Office Action Summary

10/816,668

SIMOFI-ILYES ET AL.

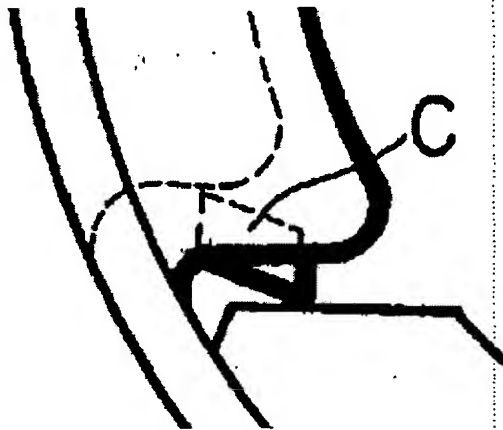
With respect to claims 1,3,6,10 & 13 McMillen teaches a stator assembly for a brush-type permanent magnet DC motor having N number of poles, the stator assembly comprising: A stator body (Fig. 3, #12) having a central axis and an annular inner wall disposed about the central axis, the inner wall having an entirely curved raised portion (Fig. 3, #54) and an entirely curved recess (Fig. 3, #42) adjacent to the raised portion, the raised portion being closer to the central axis than the recess, the at least one raised portion having a flux recovery feature (Col. 1, Lines 26-45), and a permanent magnet (Fig. 3, #50) mounted within the recess and defining with the flux recovery feature, a magnetic circuit, wherein an inside radius of the magnet is substantially the same as, and concentric with, an inside radius of the raised portion as measured from the central axis, wherein, in section, the at least one raised portion is joined directly with a surface defining the recess by a generally S-shaped structure thereby defining an entirely curved transition there-between, wherein a number of raised portions is equal to a number of magnets and the number of magnets is $N/2$, but it does not explicitly teach the generally S-shaped structure defining an entirely curved and non-planar transition. However, Yamaguchi teaches a stator body wherein, in section, the at least one raised portion (Fig. 3, d) is joined directly with a surface defining the recess (Fig. 2, #1a) by a generally S-shaped structure thereby defining an entirely curved and non-planar transition there-between (as seen in Fig. 3, enlarged below). It would have been

obvious to one of ordinary skill in the art at the time of the invention to modify the S-shaped structure of McMillen in view of the S-shaped structure as taught by Yamaguchi because it provides a means for holding magnets in a case without requiring any binding agent, springs or screws (Yamaguchi, Abstract).
